Levy Nuclear Plant/PEF
SAJ-2008-00490 (IP-GAH)
Response #5 to Corps Position Letter dated June 23, 2011

Levy Nuclear Plant Units 1 and 2
Response #5 to Corps Position Letter for USACE-SAJ-2008-00490, dated June 23, 2011

**LEVY NUCLEAR PLANT PROJECT
TEMPORARY IMPACT RESTORATION PLAN**

**LEVY NUCLEAR PLANT PROJECT
INVASIVE AND EXOTIC SPECIES MANAGEMENT PLAN**

Temporary Impacts
Levy Nuclear Plant Project Temporary Impact Restoration Plan
Levy County, Florida

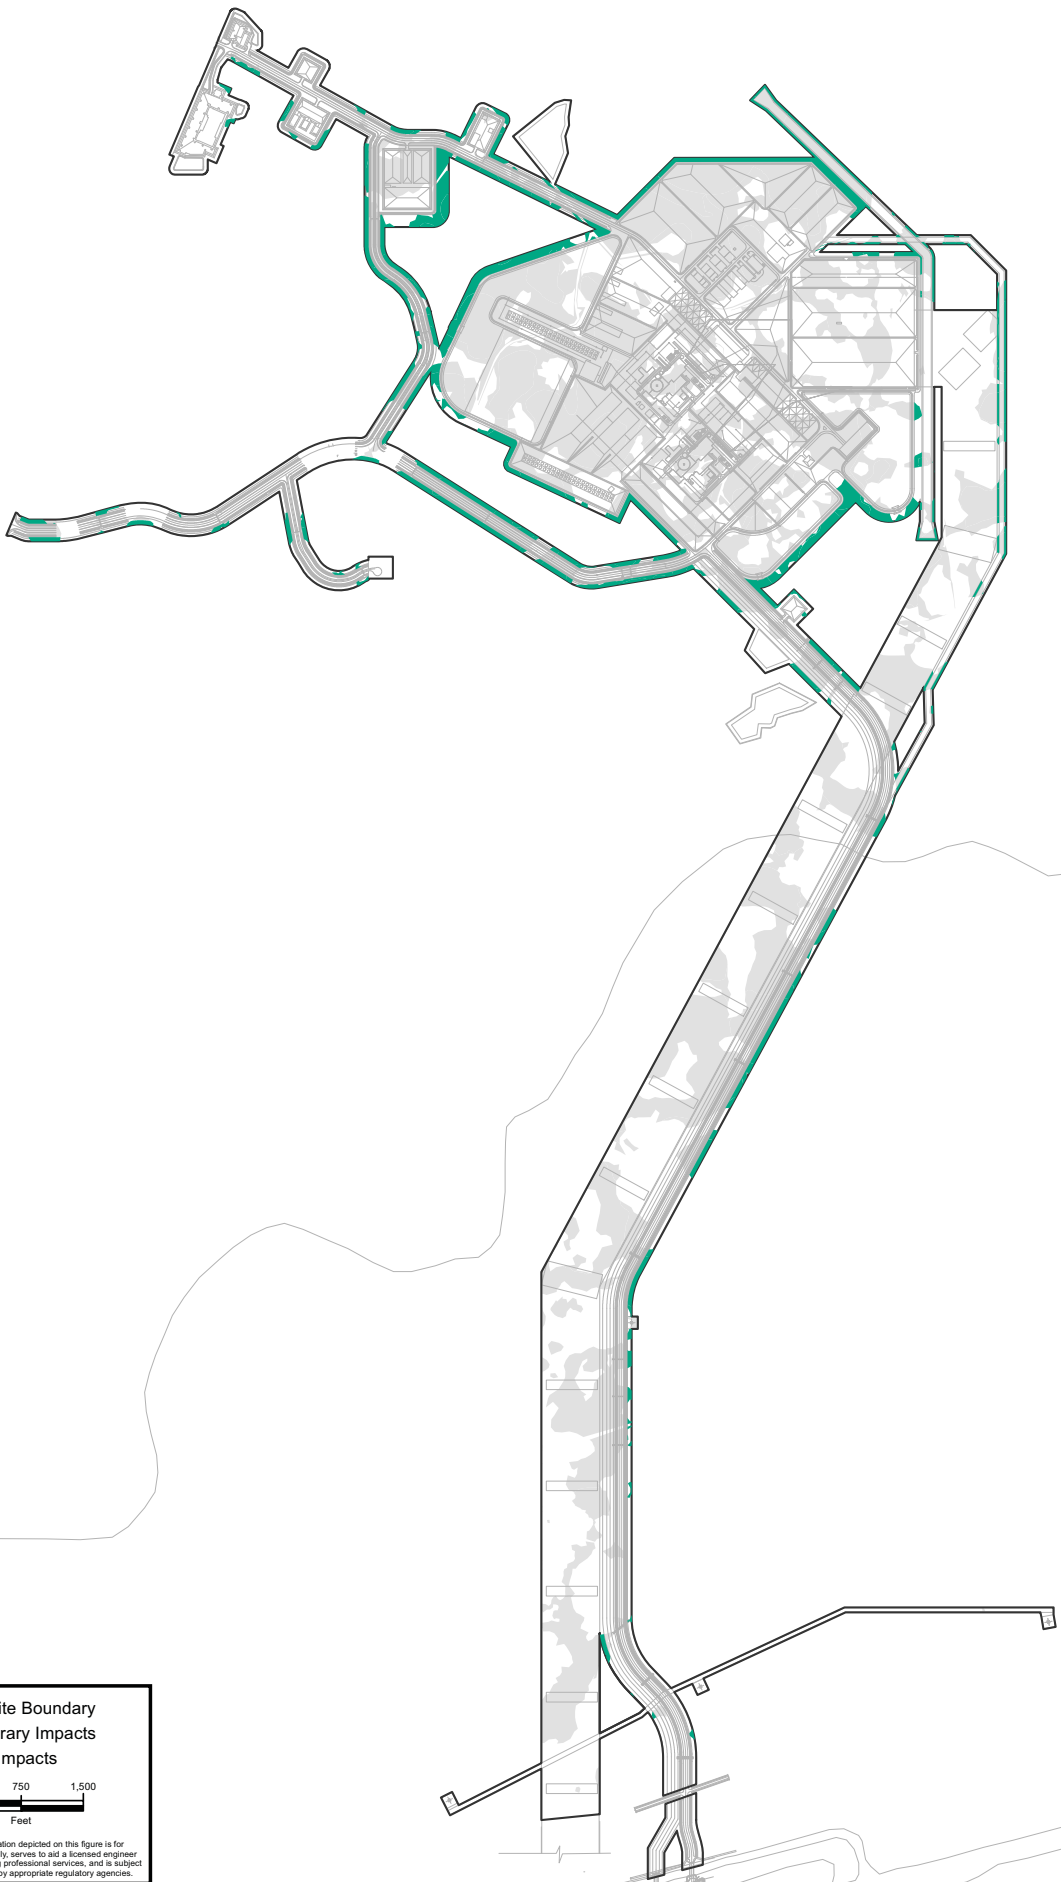
All temporary work/fill/excavation areas in wetlands and other waters should be minimized. Temporarily impacted wetlands should be restored at a minimum to their pre-impact condition. Provide a wetland restoration plan for all temporarily impacted wetlands, which would be restored. The plan should have drawings and be sufficiently detailed to show and describe type of wetlands to be temporarily impacted, the goals of the restoration, timing of restoration, etc. The plan should be similar to a wetland mitigation plan. Explain in detail justification for any temporary wetland impact areas that PEF proposes not to restore to prior wetland conditions.

PGN Response to USACE RAI: Work in wetlands and other waters has been avoided and minimized as described previously in response to USACE RAI Other #2 submitted via letter Serial: NPD-MISC-2011-016. Temporarily impacted wetlands will be restored as described in the attached Levy Nuclear Plant Project, Temporary Impact Restoration Plan, November 2011.
